Watts Bar Nuclear Plant, Unit 2  
NRC Docket No. 50-391

**Subject: WATTS BAR NUCLEAR PLANT (WBN) UNIT 2 – REQUEST FOR  
ADDITIONAL INFORMATION (RAI) GROUP 6 REGARDING “FIRE  
PROTECTION REPORT” (TAC NO. ME3091)**

### Response to NRC's Round 5 Request for Additional Information Regarding "Fire Protection Report"

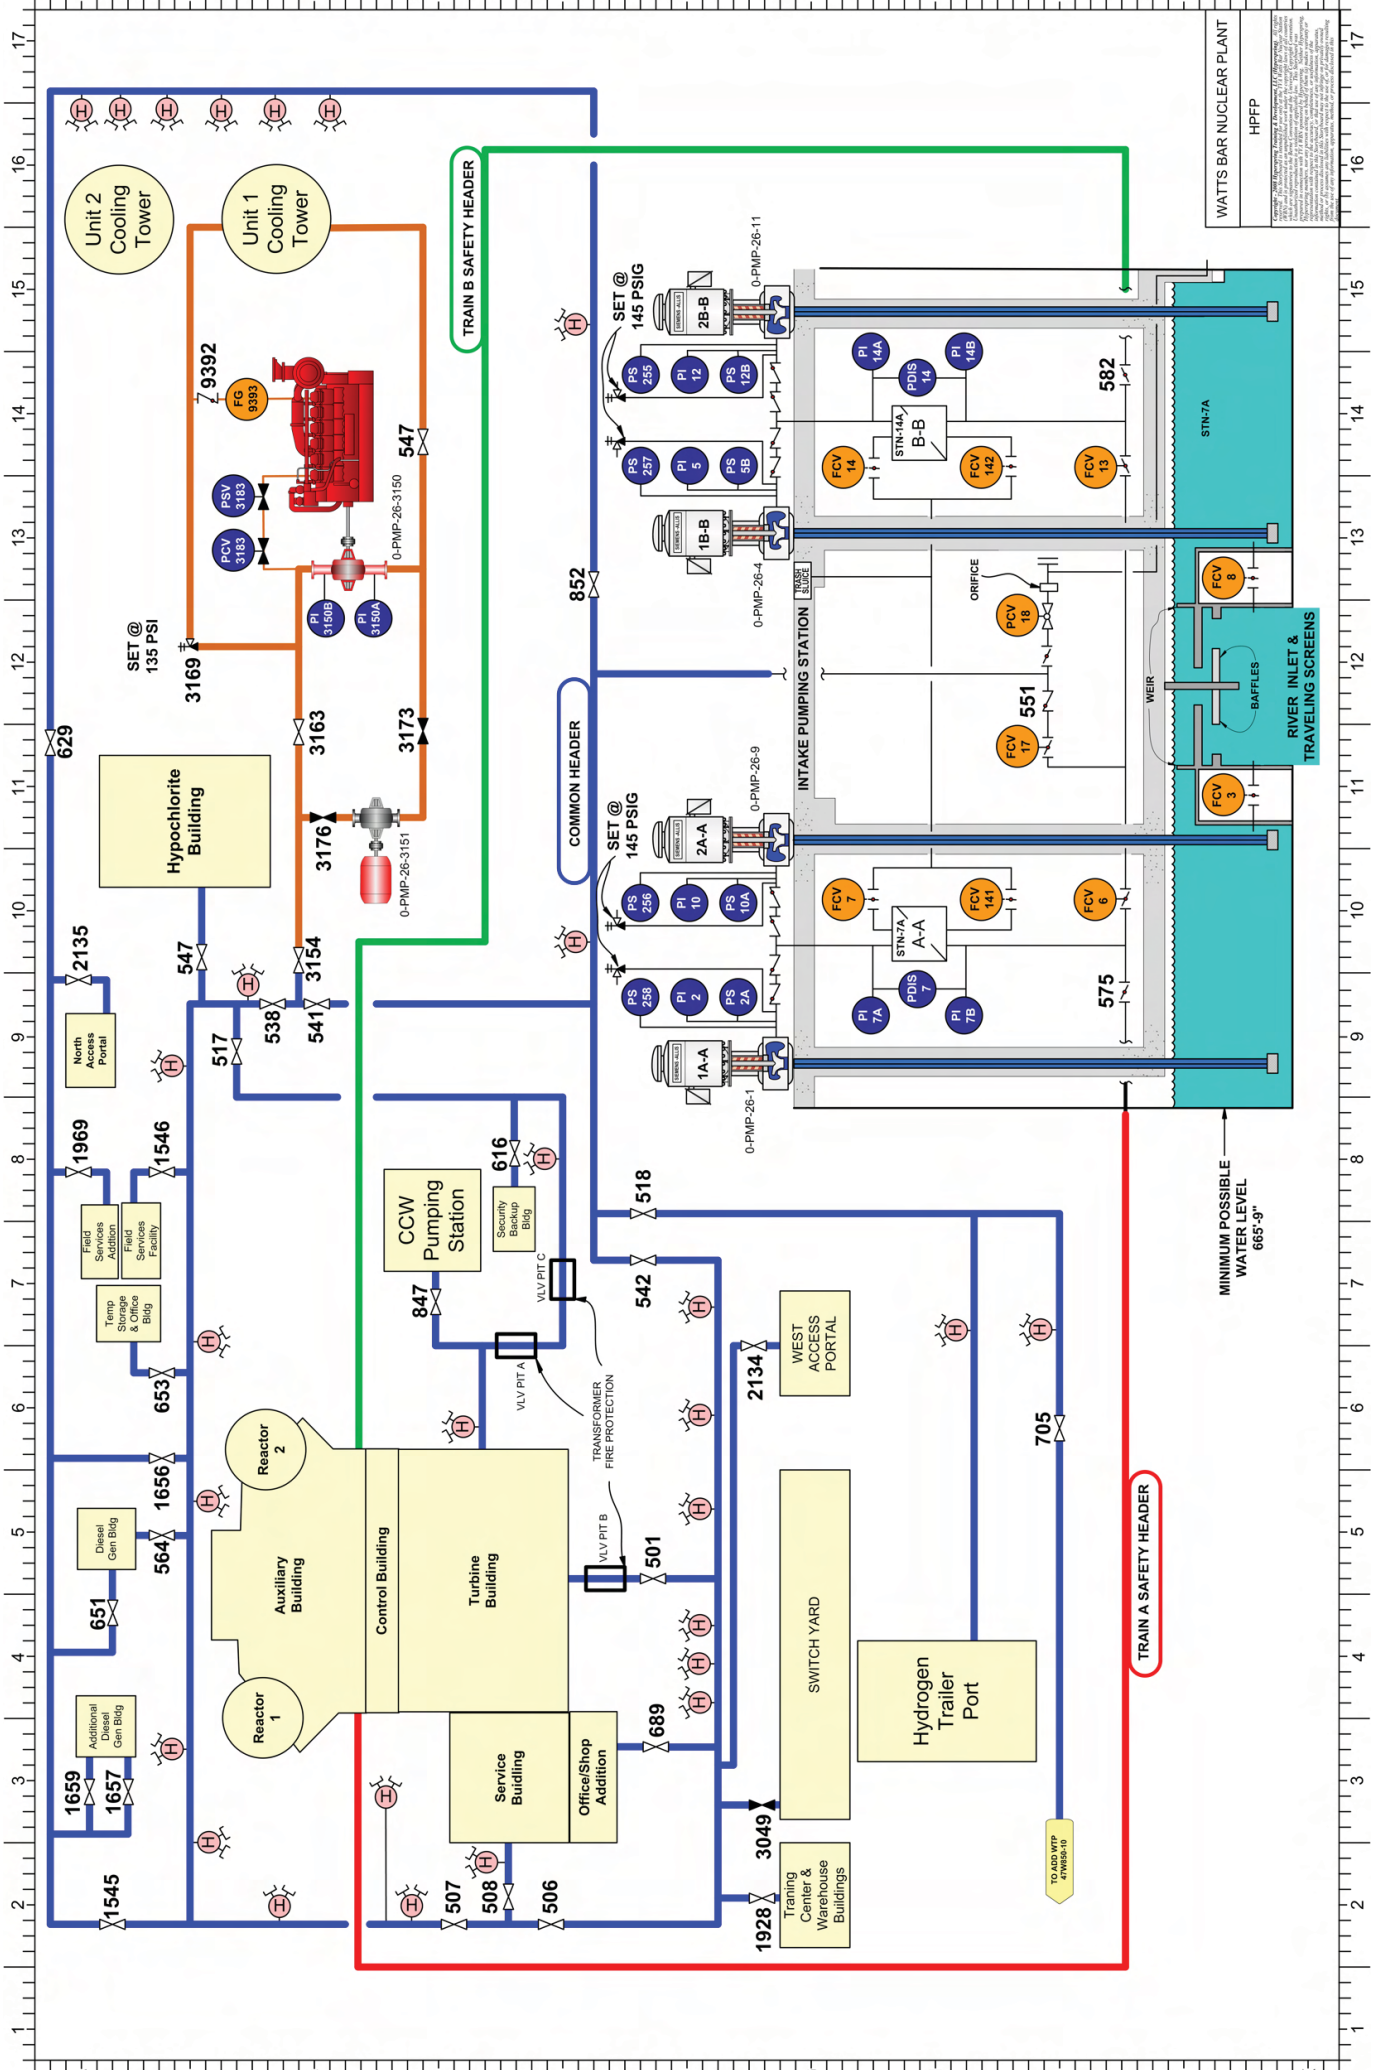
*[1] Provide a detailed description of the high pressure fire protection system configuration. The description should include, but not be limited to the following:*

Attached is a simplified sketch of the majority of the HPFP system. This sketch does not show the loop that serves the Training Center and the warehouses to the north of the Protected Area. The A train, the B train, and the main common headers are shown. In addition, there is a loop inside the Turbine Building and a loop inside the Auxiliary Building. The Turbine and Auxiliary Building loops are intertied in two diverse locations at the interface of the Turbine and Auxiliary Buildings. The Turbine Building loop is connected to the yard loops at two locations and has one connection to the Service Building. During normal operation, the system is interconnected with all sectionalizing valves open.

During the design bases flood, sectional valves are closed to ensure the Train A and B headers are established to support the safety function of the fire protection system to provide Auxiliary Feedwater. The buried trained headers enter the Auxiliary Building on opposite sides and connect to the Auxiliary Build HPFP header loop. When the sectional valves are closed for flood mode, the ties to the Turbine Building are isolated and the supply from the buried trained headers is sectionalized to A train and B train and both can supply Auxiliary Feedwater.

1. The demineralized water purification process (shown on the Figure II-45.A as "ADD WTP") is located in the yard such that the feed is via Turbine Building to yard to ADD WTP.
2. The main HVAC loads are in the Service Building and the Main Office Building, and the feed is via Turbine Building to Service Building.
3. One HVAC load in the Control Building is fed by the Turbine Building loop.
4. The auxiliary boiler feed pump seal cooler is fed by the Turbine Building loop.
5. The as-needed service water connections are fed via the Turbine Building through the yard loops to the individual buildings.
